# Access Compliance Report

## Public Rights-of-Way

### (Curb Ramps)

Intersection ID: 48132	Main Street: ACORN_CREEK_LN	Cross Street: HIGHLAND_CREEK_PY	Location: N
ADA ID: 3339B20E92FB	Ramp Type: Perp	Initial Pass/Fail: Fail	Overall Compliance: No
			Severity Score: 13.75

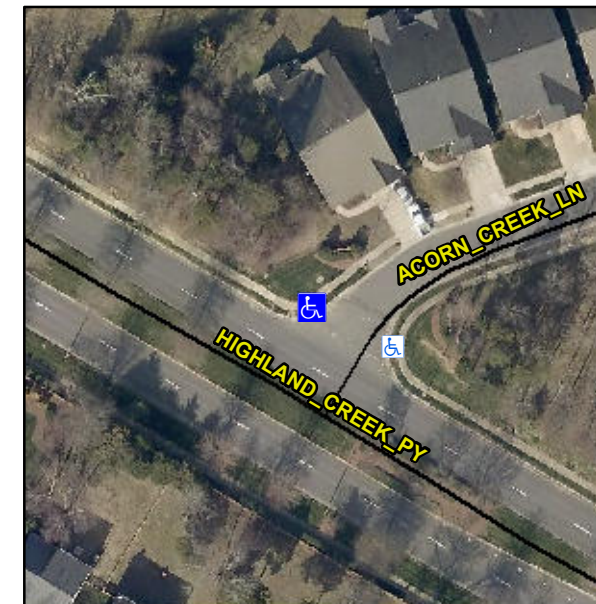
**R304.2.2, R304.5.3**

Compliance	Description	Data	Compliance	Description	Data
N/A	Ramp Length (in)	48.0	No	Ramp Slope (%)	9.5
Yes	Ramp Width (in)	48.0	No	Ramp XSlope (%)	2.4
N/A	Flare Type LT	N/A	N/A	Flare Type RT	N/A
N/A	Flare Slope LT (%)	N/A	N/A	Flare Slope RT (%)	N/A
N/A	Flare Traversable LT?	N/A	N/A	Flare Traversable RT?	N/A
N/A	Landing Length (in)	N/A	N/A	DWS Provided?	N/A
N/A	Landing Width (in)	N/A	N/A	DWS Contrast?	N/A
N/A	Landing Slope (%)	N/A	N/A	DWS Length (in)	N/A
N/A	Landing X Slope (%)	N/A	N/A	DWS Full Width?	N/A
N/A	Landing Curb? (Y/N)	N/A	N/A	DWS Offset (in)	N/A
N/A	Shared Landing?	N/A			
N/A	Gutter Ponding?	N/A	N/A	Gutter Slope (%)	N/A
N/A	Gutter Lip Ht (in)	N/A	N/A	Gutter X Slope (%)	N/A
N/A	Painted X Walk1?	No	N/A	Painted X Walk2?	N/A
	X Walk 1 Direction	To SE		X Walk 2 Direction	N/A
N/A	X Walk 1 Width (in)	N/A	N/A	X Walk 2 Width (in)	N/A
	X Walk 1 Slope (%)	1.3		X Walk 2 Slope (%)	N/A
	X Walk 1 X Slope (%)	1.0		X Walk 2 X Slope (%)	N/A

**Remove & Replace Entire Ramp.**
